ZAYO'S PRINEVILLE TO RENO PROJECT

CPUC MINOR PROJECT REFINEMENT FORM

Date Requested: 15 Oct 2024 submitted to CPUC on October 21, 2024	Report No.: 6
Date Approved: 10/25/2024	Approval Agency: Caltrans, in addition to CPUC
Property Owner(s): Caltrans (State Route 395 ROW)	Location/Milepost: PM M-26.1 to M- 26.7(S to N)
Land Use/Vegetative Cover: Ruderal (maintained highway shoulder near edge of pavement)	Sensitive Resources: Waterways are present (adjacent to North Fork Pit River). No other sensitive resources present. (See project webmap.)

SHEET NO.: 79 OF 94

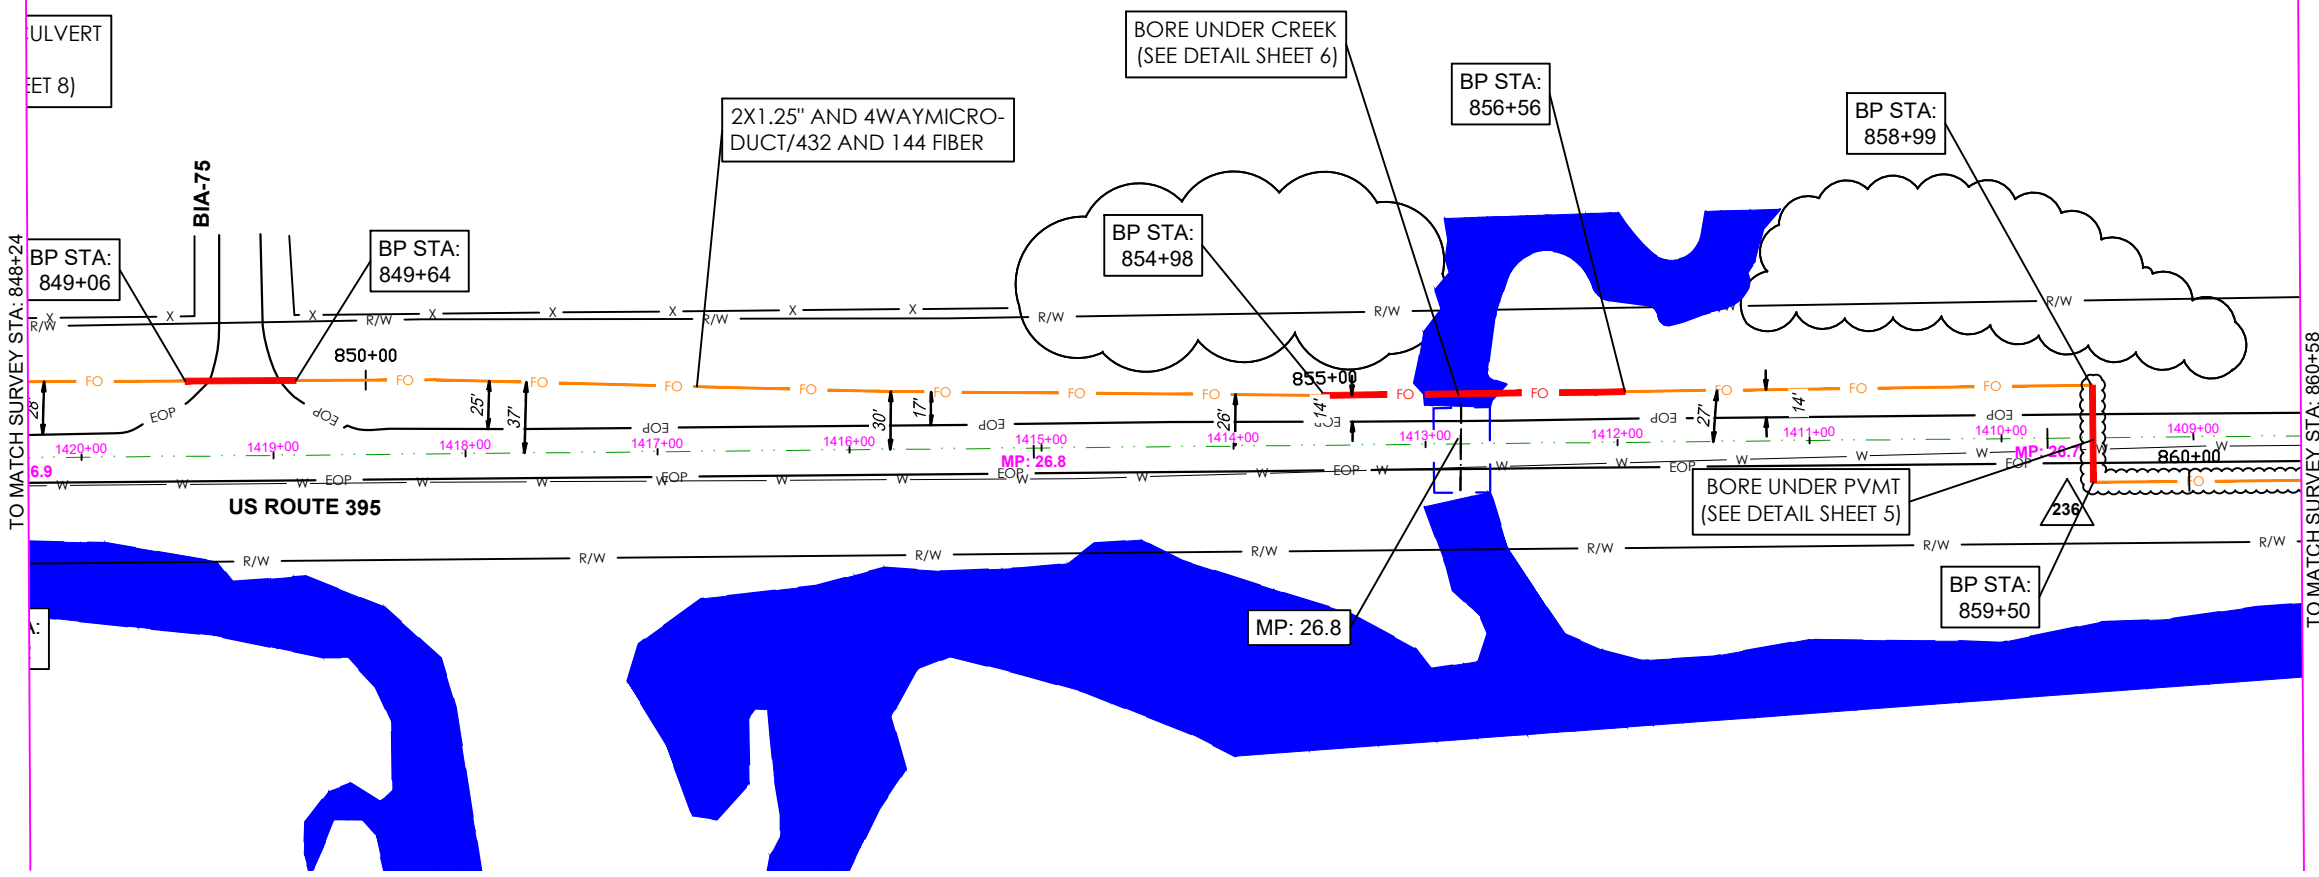
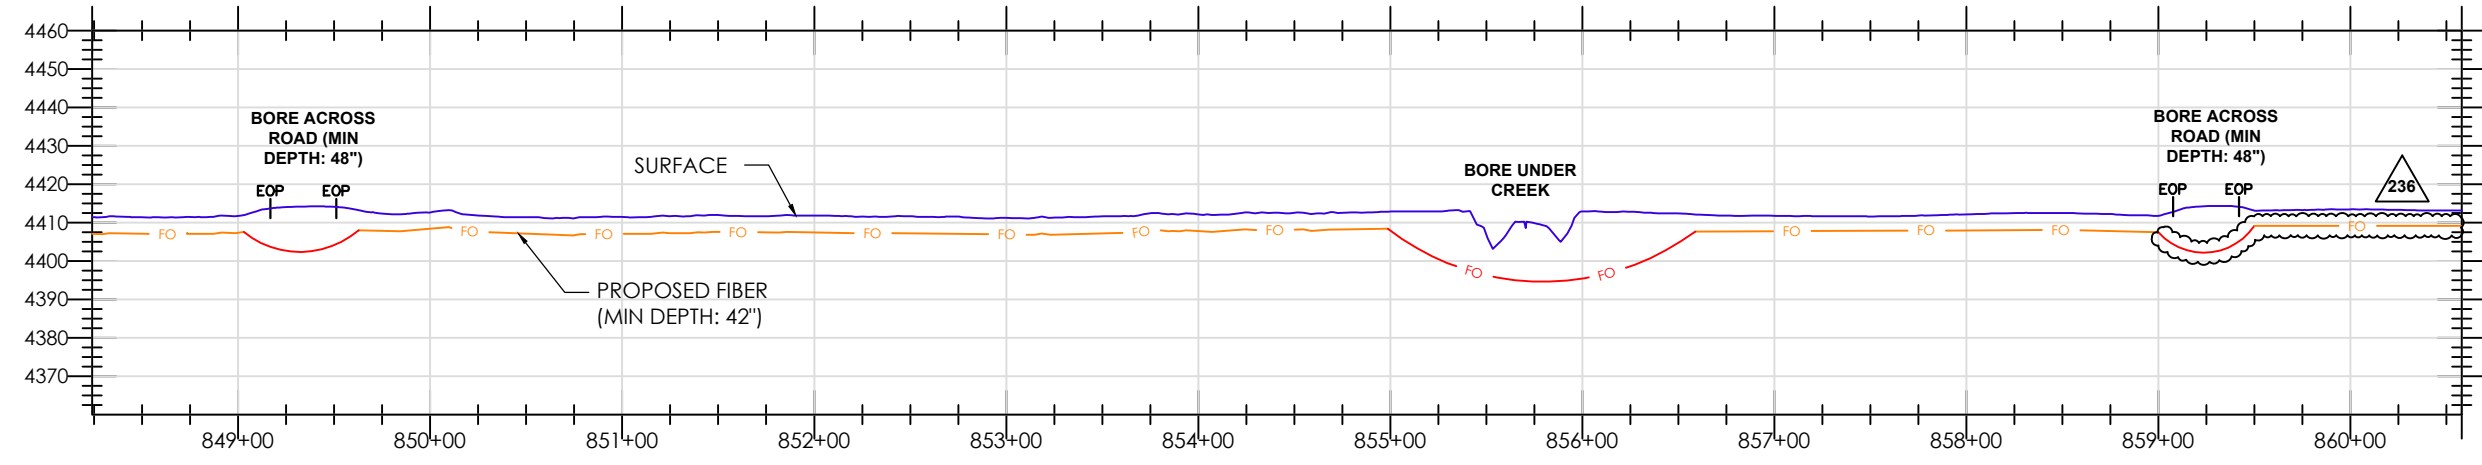
RFI NO. 0236
SHIFT ALIGNMENT TO WEST SIDE 10 FEET FROM EOP
STA 859+00 TO STA 880+00

SHEET NO.: 80 OF 94

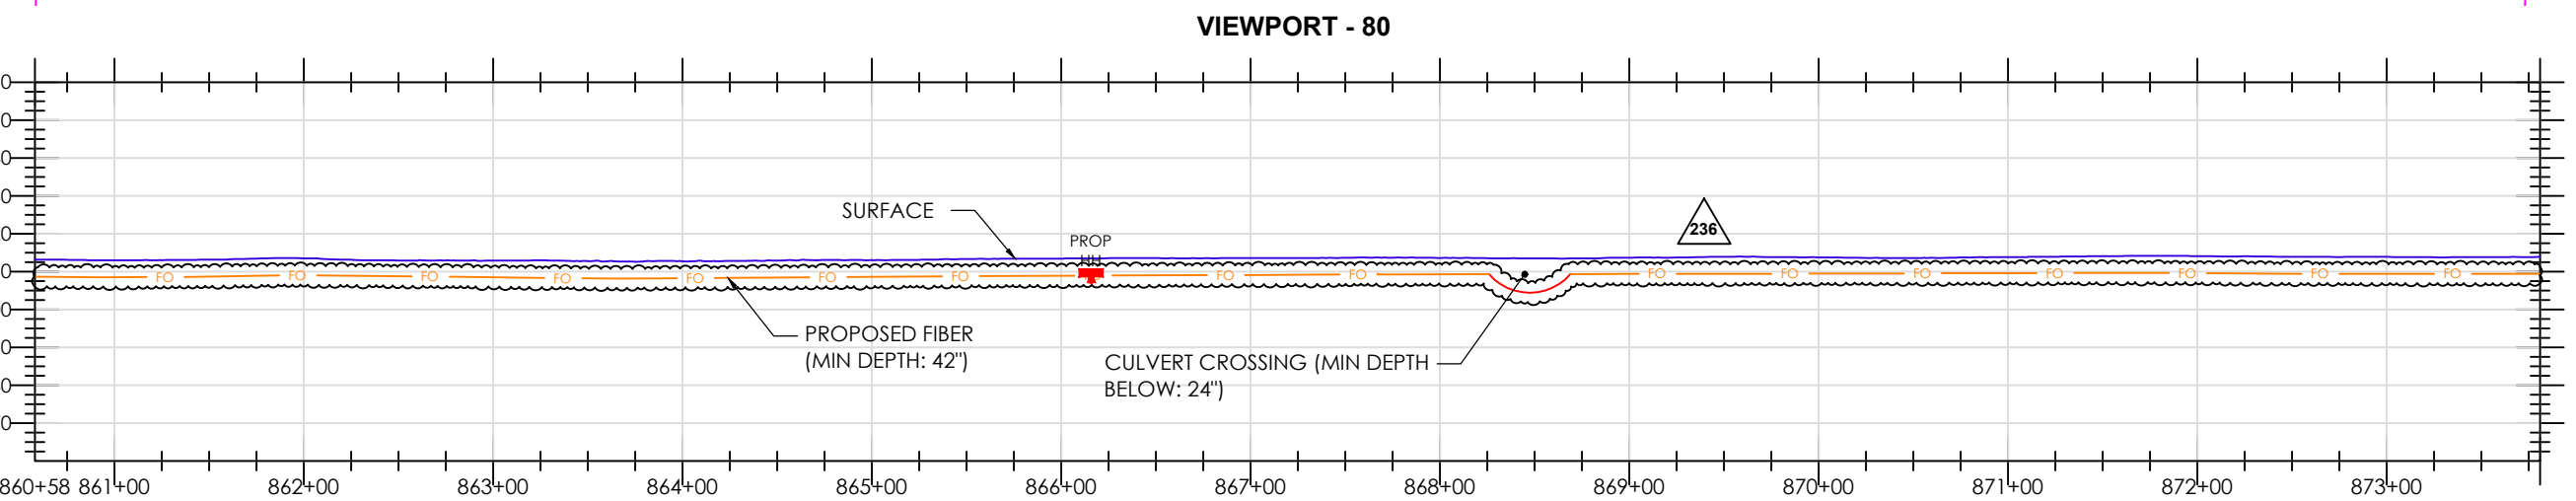
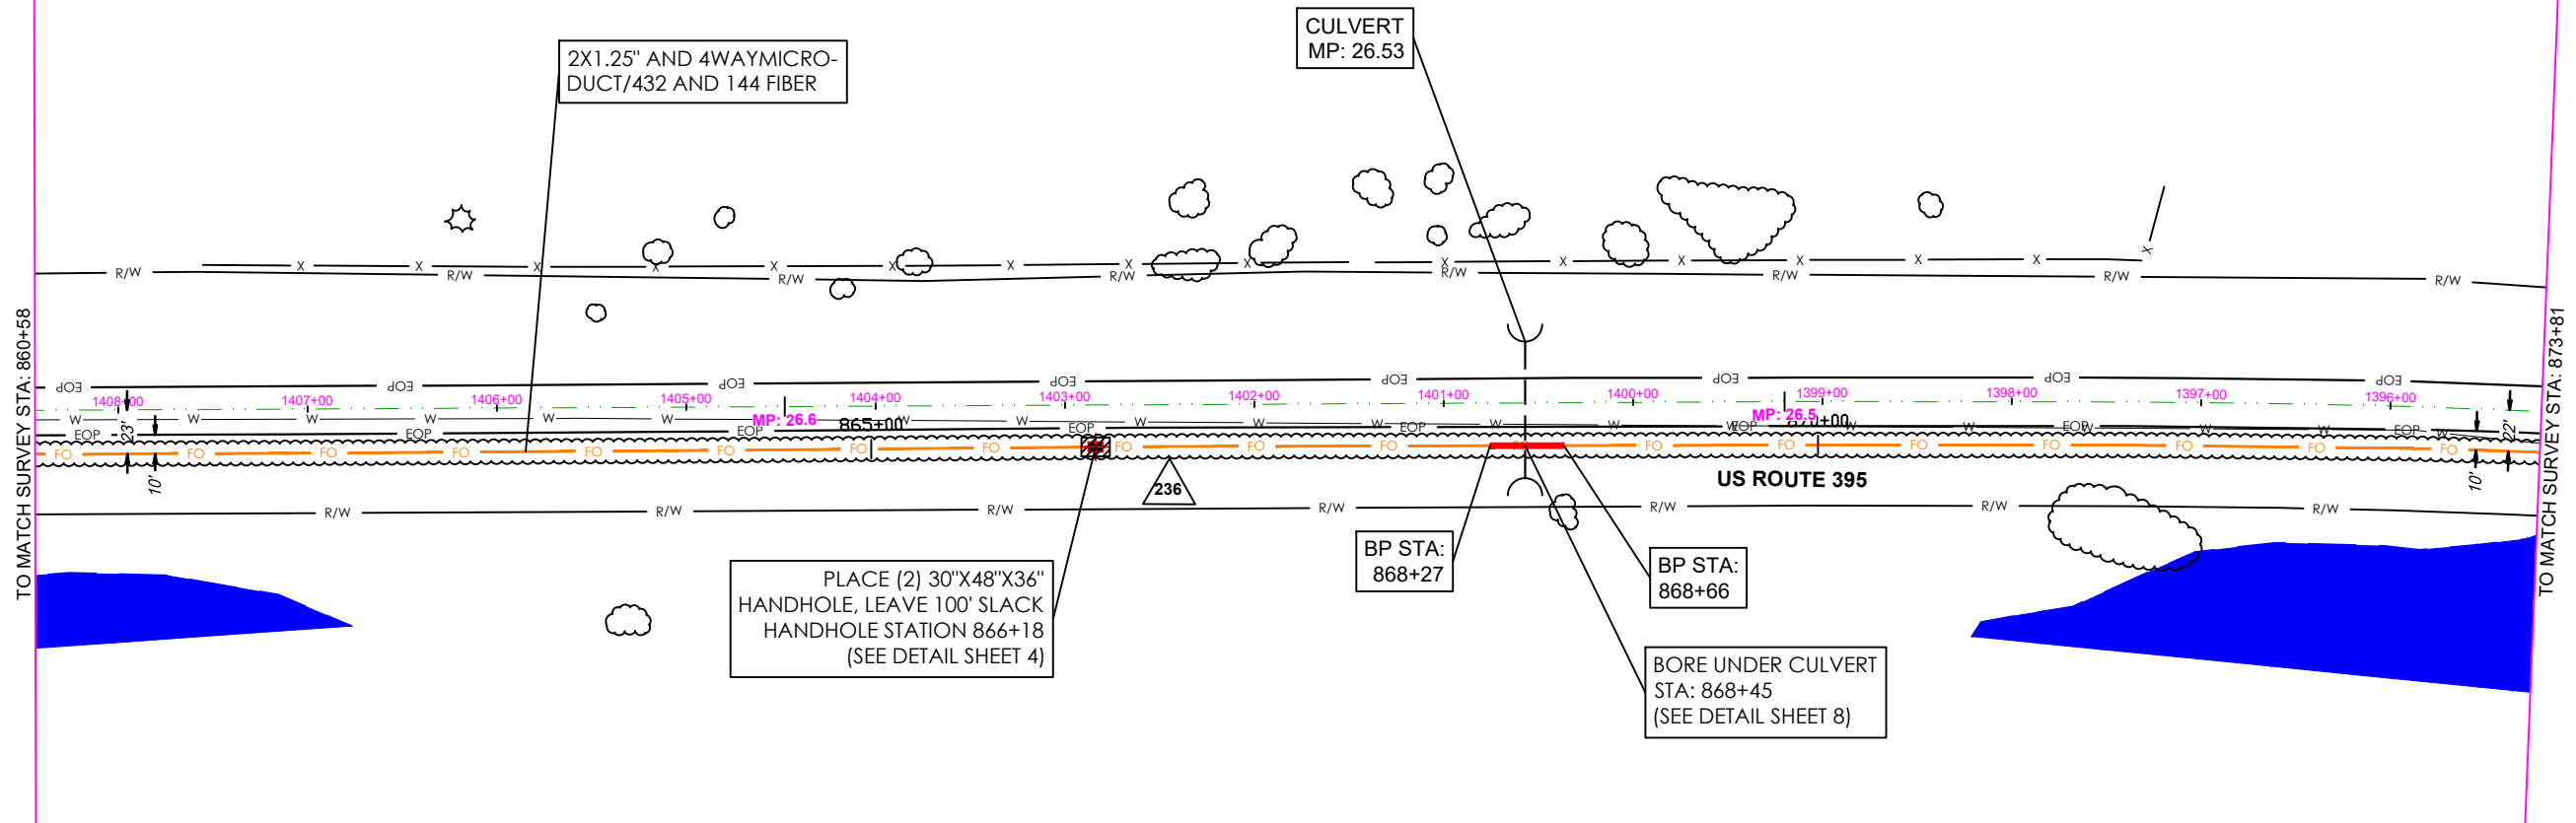
RFI NO. 0236
SHIFT ALIGNMENT TO WEST SIDE 10 FEET FROM EOP
STA 859+00 TO STA 880+00

SHEET NO.: 81 OF 94
DATE: 10/2/24

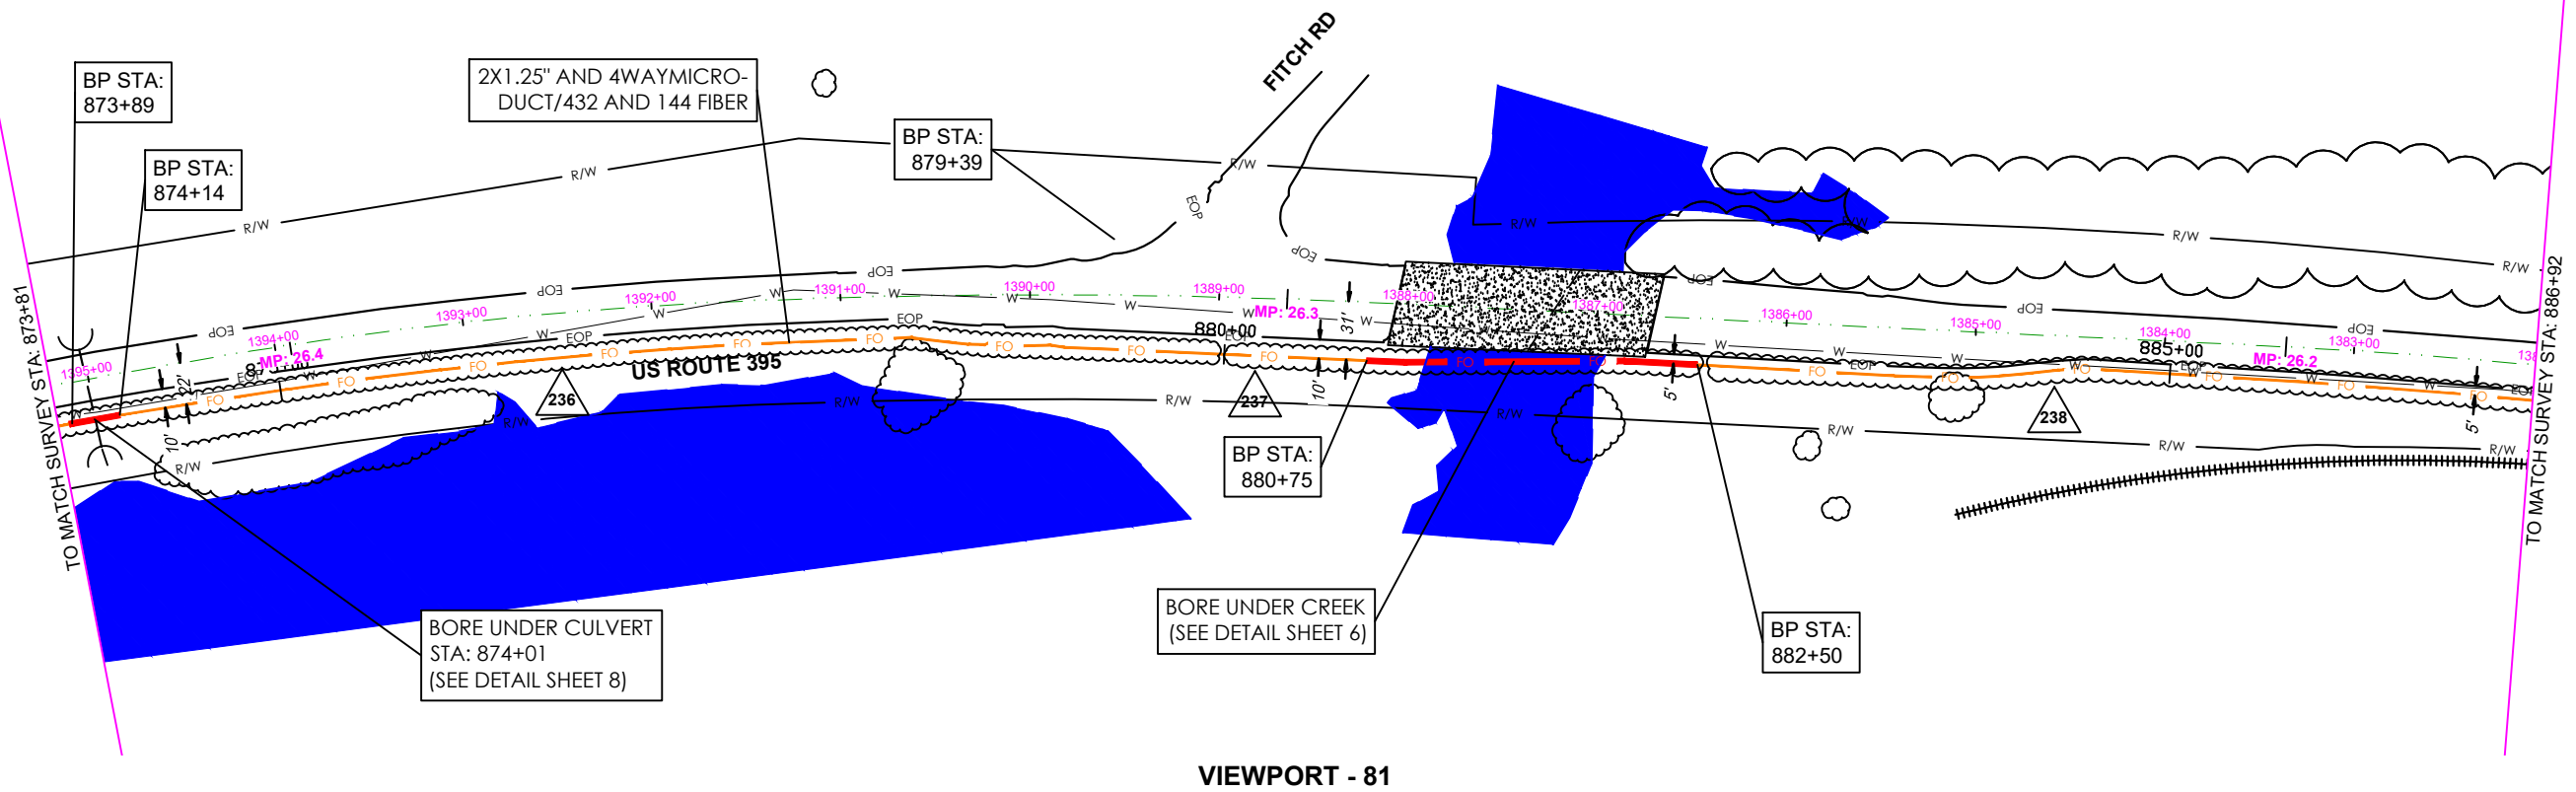
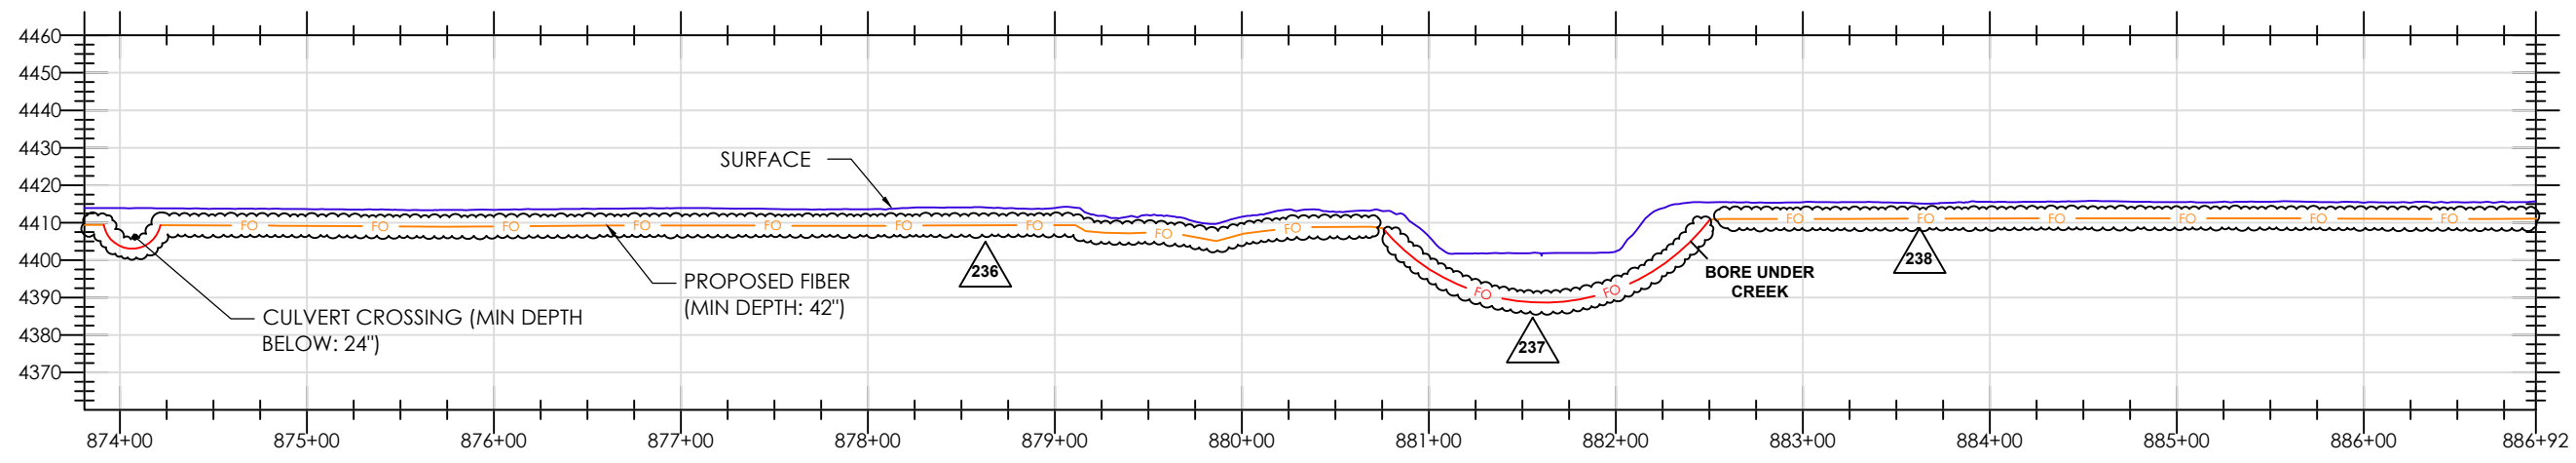
RFI NO. 0236
SHIFT ALIGNMENT TO WEST SIDE 10 FEET FROM EOP STA 859+00 TO STA 880+00 10/02/2024

RFI NO. 0237
BORE UNDER CREEK ON WEST SIDE STA 880+00 TO STA 882+25 10/02/2024

RFI NO. 0238
SHIFT ALIGNMENT 5 FEET FROM EOP ON WEST SIDE STA 882+25 TO STA 890+50 10/02/2024
